Access Compliance Report

Public Rights-of-Way

Intersection ID: 26115	Main Street: CARMEL_CHACE_DR	Cross Street: CARMEL_RD	Location: SE
ADA ID: 2E5A250ADED2	Ramp Type: PerpDiag	Initial Pass/Fail: Fail	Overall Compliance: No
		Severity Score: 25

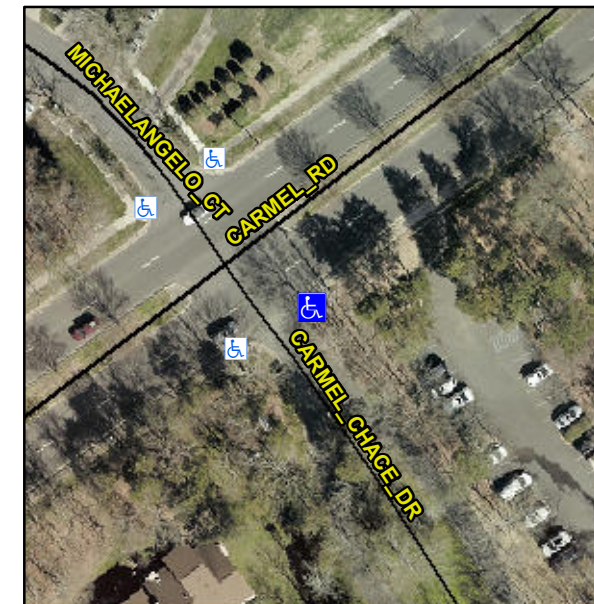
Not Found, R304.5.3

Compliance	Description	Data	Compliance	Description	Data
N/A	Ramp Length (in)	74.0	Yes	Ramp Slope (%)	5.9
Yes	Ramp Width (in)	48.0	No	Ramp XSlope (%)	8.9
N/A	Flare Type LT	N/A	N/A	Flare Type RT	N/A
N/A	Flare Slope LT (%)	N/A	N/A	Flare Slope RT (%)	N/A
N/A	Flare Traversable LT?	N/A	N/A	Flare Traversable RT?	N/A
N/A	Landing Length (in)	N/A	N/A	DWS Provided?	N/A
N/A	Landing Width (in)	N/A	N/A	DWS Contrast?	N/A
N/A	Landing Slope (%)	N/A	N/A	DWS Length (in)	N/A
N/A	Landing X Slope (%)	N/A	N/A	DWS Full Width?	N/A
N/A	Landing Curb? (Y/N)	N/A	N/A	DWS Offset (in)	N/A
N/A	Shared Landing?	N/A			
N/A	Gutter Ponding?	N/A	N/A	Gutter Slope (%)	N/A
N/A	Gutter Lip Ht (in)	N/A	N/A	Gutter X Slope (%)	N/A
N/A	Painted X Walk1?	No	N/A	Painted X Walk2?	No
	X Walk 1 Direction	To N		X Walk 2 Direction	To W
N/A	X Walk 1 Width (in)	N/A	N/A	X Walk 2 Width (in)	N/A
	X Walk 1 Slope (%)	3.8		X Walk 2 Slope (%)	2.4
	X Walk 1 X Slope (%)	2.7		X Walk 2 X Slope (%)	2.9

Remove & Replace Curb Ramp With Two New Directional Ramps or Equivalent.
